Tentative Order No. R2-2012-XXXX

Amending Waste Discharge Requirements Order No. R2-2008-0078 for:

**U.S. Fish and Wildlife Service and
California Department of Fish and Game
South Bay Salt Pond Restoration Project (SBSRP),
Modification 1 to Phase I**

To:	San Francisco Bay Regional Water Quality Control Board	Project:	Design/Build of Ponds A16 and A17 on the Don Edwards San Francisco Bay NWR
Prepared by:	Greg Allington (McMillen)	Cc:	Jim Burby (USFWS) Eric Mruz (USFWS) Mendel Stewart (USFWS) Melissa Helton (USFWS) John Bourgeois (CSCC) Dan Axness, PE (McMillen)
Approved by:	Mort McMillen, PE (McMillen)		
Date:	September 9, 2011	Contract No:	F11PD00552
Subject:	Alviso Pond A16-A17 Restoration Design Modification Implications to Existing Environmental Permits

Figure 1. 50-Year Long Term Goal for Pond A17

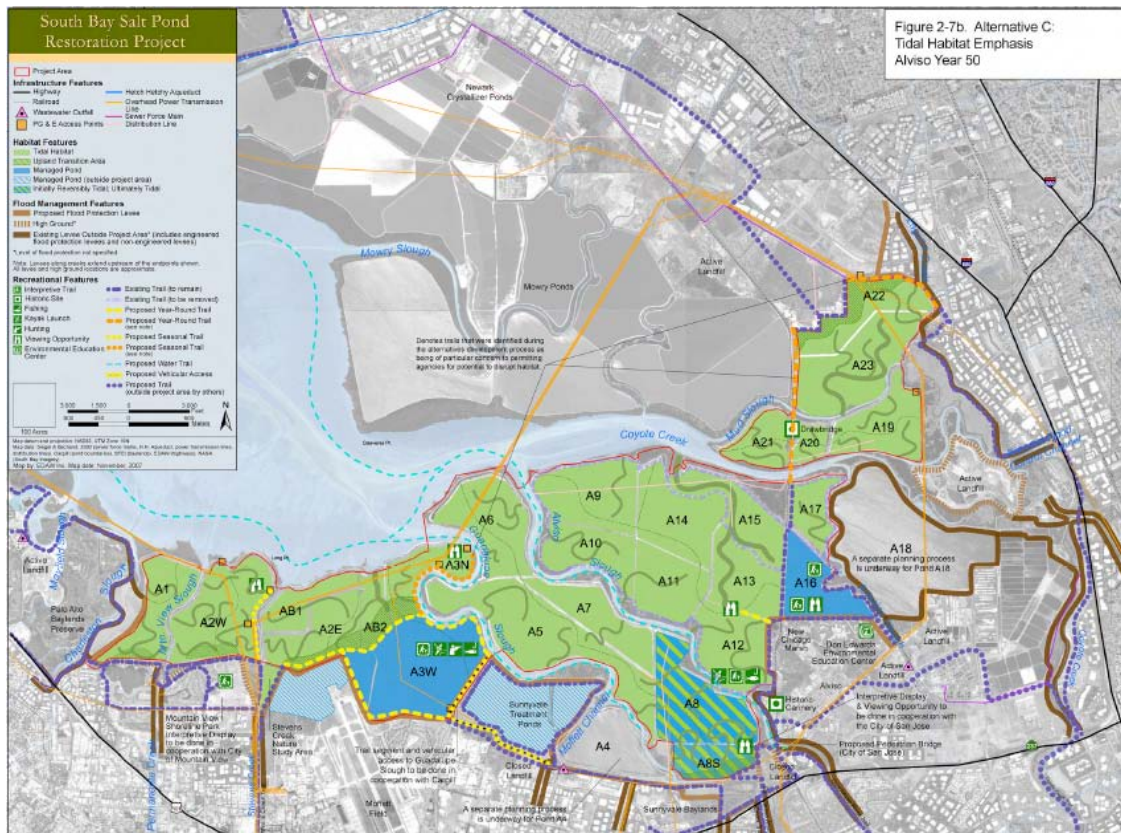
The levee breach and structure removal at the inlet of Pond A17 from Coyote Creek is not permitted under existing permit approvals. Permit approvals state that the existing structure is to remain in place with a new fish screen installed and there is no approval for a complete levee breach in any location in Pond A17. By breaching the existing intake structure, it eliminates the need for a second intake structure. As a result, there would be minimal impacts to the salt marsh habitat on the northern side of Pond A17 levee.

Lowering of the levee along the northern, eastern and southern portions of Pond A17 is not permitted under the existing permit approvals. Permit approvals state that the only source of water entering Pond A17 is through the new and existing intake structures that would both require fish screens. However, the 50-year goal for Pond A17 according to the selected alternative (Alternative C) shown on Figure 2-7b in the Final Environmental Impact Statement/Report is to restore it to tidal habitat (Figure 1). The permit approvals do not approve this levee breaching and lowering; however, the intended use does meet the criteria of the 50-year long-term objective for this project.

Once the existing A17 Intake WCS is removed and the A17 levee is lowered, tidal flows will enter Pond A17 unobstructed. A report prepared by the United States Geological Survey titled *Sediment Deposition and Erosion in South San Francisco Bay, California from 1956 to 2005* prepared in 2006 describes sedimentation in the vicinity of Pond A17. Based on the findings of this report, it is expected that sediment will continue to accumulate south of the Dumbarton Bridge. This new tidal water regime is expected to transport sediment into the pond area filling in the low elevation areas over time to match the existing marsh elevation of approximately MHW. In order to keep the west borrow ditch clear of sediment accumulation and facilitate the transport of water at lower elevations than the pond bed, a water control berm is proposed for the eastern borrow ditch and is described in detail in Section 3.9. Monitoring of Pond A17 sediment accumulation will be performed on a yearly basis as outlined in the *South Bay Salt Pond Restoration Project Phase 1 Monitoring Plan* prepared in 2008 which will include monitoring of the subtidal/open water habitat and intertidal mudflat areas. The monitoring will be compared against the Phase 1 adaptive management triggers and potential management actions to determine the success of the restoration.

POND A17 PLAN

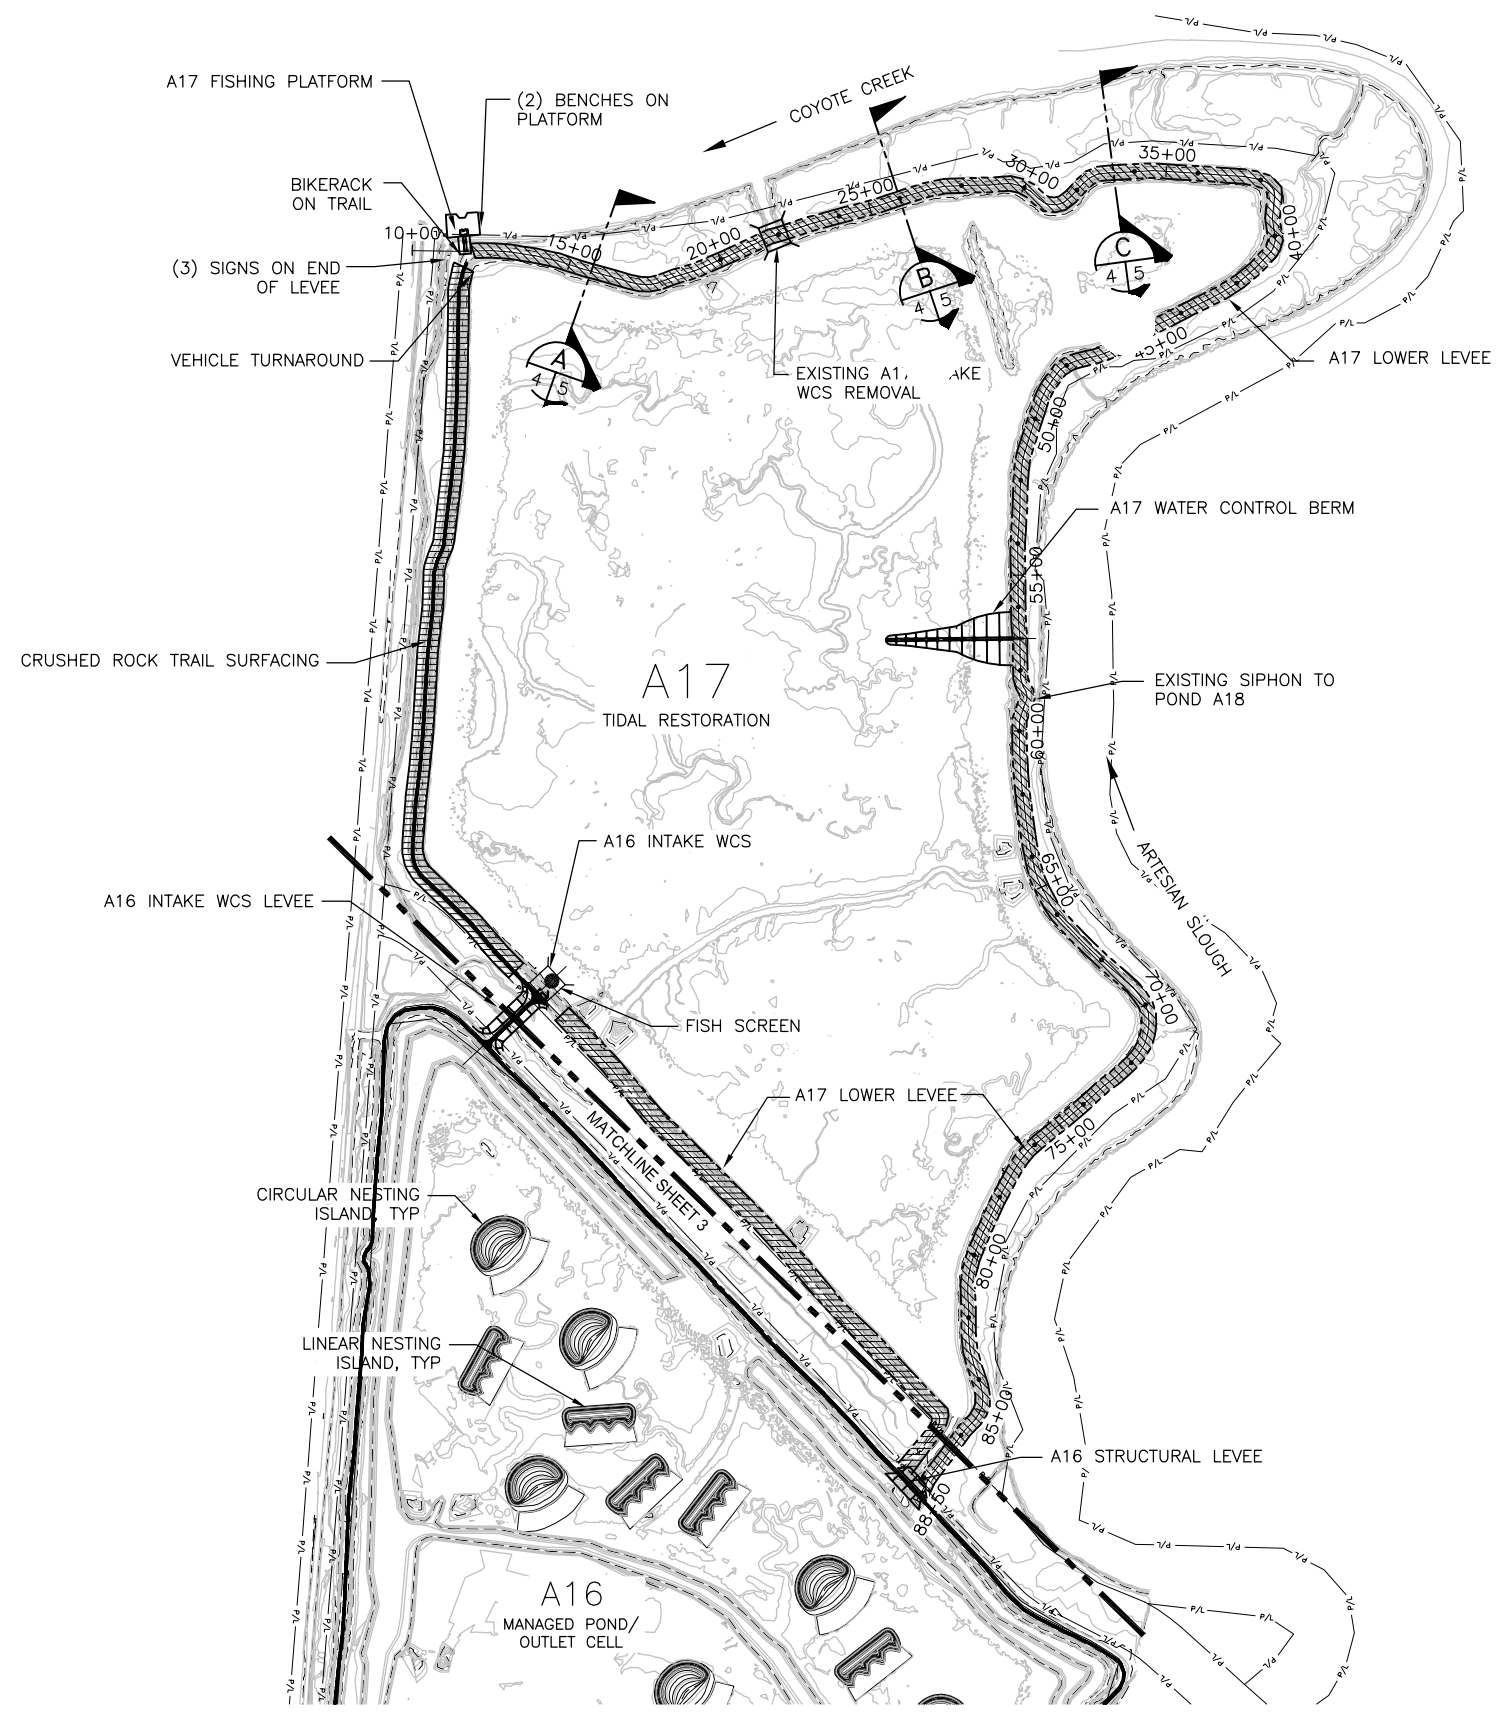
- Completely remove the existing A17 intake structure.
- Lower approximately 2,050 feet of A17 levee along Coyote Creek to approximately MHW or 7.0 feet NAVD.

- Lower approximately 5,000 feet of A17 levee along Artesian Slough to approximately MHW or 7.0 feet NAVD.
- Leave sporadic upland hummocks for escape cover for salt marsh harvest mice during high tide events every 200 feet in portions of the levee adjacent to suitable habitat.
- Lower approximately 2,260 feet of A17 levee along the southern boundary to 4.0 feet NAVD.

The removal of the existing A17 Intake WCS in Stage 2 would tidally connect Pond A17 with Coyote Creek, and over time (50 year goal) it would create pickleweed marsh habitat and restore the tidal hydraulic connection between Pond A17 and the adjacent sloughs. There are no plans to dredge the existing pilot channel or make it wider after the existing intake structure is removed. This channel is expected to stabilize itself over time. Salvageable material from the intake structure would be used in other restoration tasks and all unsalvageable material would be disposed off-site at an appropriate facility.

The A17 levee along the southern portion of A17 would also be lowered during Stage 2. This levee would be removed to an elevation of 4.0 feet NAVD to match the existing marsh habitat. New structural levees would be built from this material at the new A16 levee and at the new A16 intake WCS levee to separate Pond A16 from the new tidal habitat.

DON EDWARDS SAN FRANCISCO BAY NWR
POND A16-A17 RESTORATION
A17 LOWER LEVEE SECTIONS

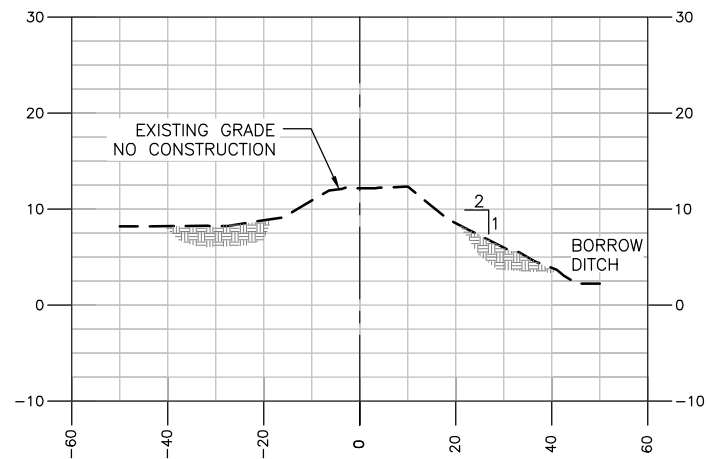
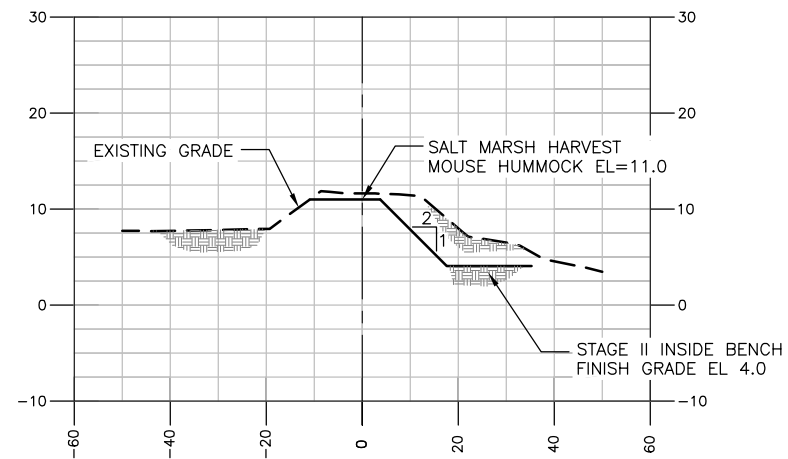
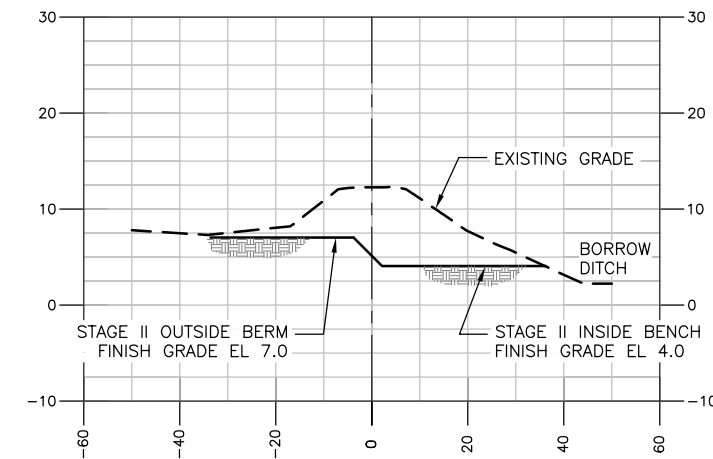
The dry material excavated from the lowered levees would be used to construct the nesting islands and levees during Stage 2. If excess material is available from the levee lowering, it will be placed into the adjacent borrow ditch. Lowering the levee to the existing adjacent marsh habitat would reduce erosion when tidal water flows through the marsh habitat into Pond A17. Sporadic hummocks above the high tide elevation would be left for escape cover for salt marsh harvest mice.

Lowering the A17 levee to approximately MHW would remove all upland areas that would stay dry during high tide events. The salt marsh harvest mouse has not been documented to inhabit areas adjacent to the A17 levee; however, suitable habitat is present and harvest mice may be present. During high tide events that inundate the marsh habitat, harvest mice escape to dry ground. Sporadic upland hummocks (approximately 10 feet in diameter at the top and side slopes of 3:1) spaced approximately every 200 feet would be left on the levee to create this escape habitat for harvest mice during high tide events (Sheet 5). USFWS specialists have been consulted regarding the upland hummocks proposed for salt marsh harvest mouse escape habitat. Even though mice have not been documented in this area, the hummocks will provide suitable habitat for mice if they migrate into this area.

CIRCULAR NESTING ISLANDS PLAN

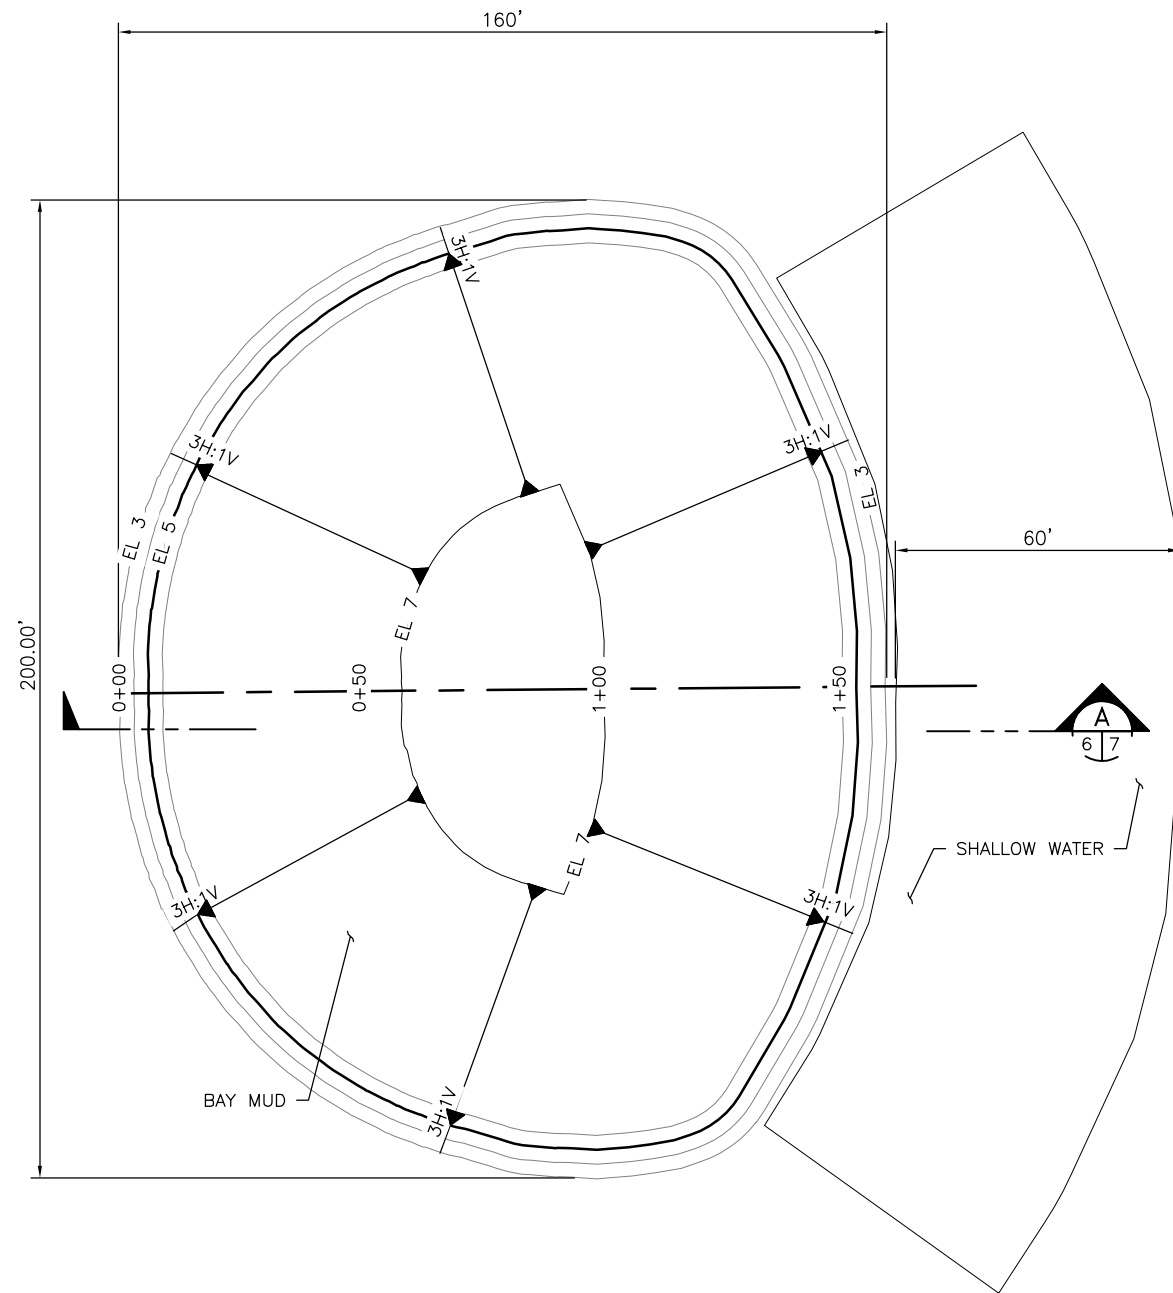
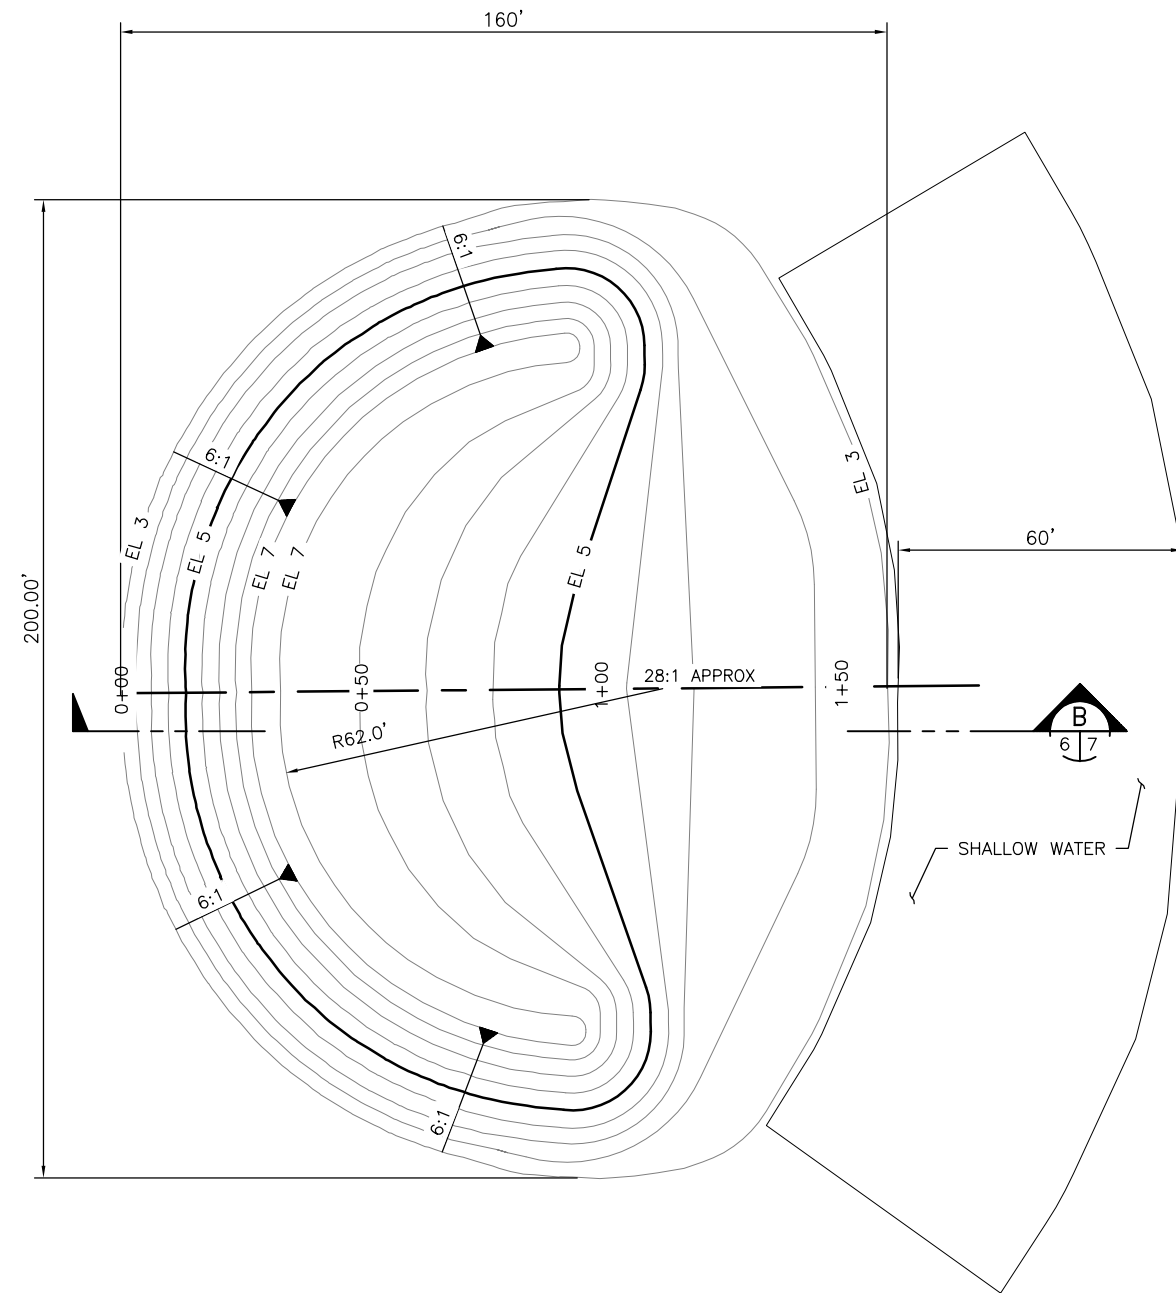
The sequence for the island construction would involve constructing the islands during Stage 1 with bay mud or imported fill material as approved in the existing permits. The islands would be built to an elevation of approximately between 5.0 and 7.0 feet NAVD in height. This material would be allowed to dry and then it would be reshaped during Stage 2 after the islands have settled. The nesting islands would be allowed to settle while other construction tasks (i.e.-A16 Outlet WCS and A16 Wildlife Viewing Platform) are being constructed during Stage 1. After other site restoration tasks are completed, the islands would be shaped to final design at an elevation of 7.8 feet NAVD and the Stage 2 levee lowering dry material or bay mud would be placed on the islands. The average island height would be overbuilt by 50% to account for additional settlement of the bay mud under the dry fill material.

The McMillen design approach proposes to construct 16 islands (8 circular and 8 linear) in Pond A16 during Stage 1 and 2 construction activities. The permit approvals state that 50 islands (25 circular and 25 linear) are to be constructed in Pond A16 as stated on page 11 (Finding 27) of the Order. The number of nesting islands was reduced based on the available amount of on-site material to construct the islands and the high cost associated with importing clean fill material. The proposed number of 16 nesting islands reflects the amount of available material located in the A17 levee and the Bay Mud located in Pond A16 in relation to a feasible cost to construct these islands. The McMillen design allows for additional nesting islands to be constructed in Pond A16 without constructing any other water control structures in the pond itself. Depending on future funding in subsequent phases of this project, the potential for up to 34 additional nesting island locations are available within Pond A16. The potential future islands would be constructed using local bay mud or imported fill material.
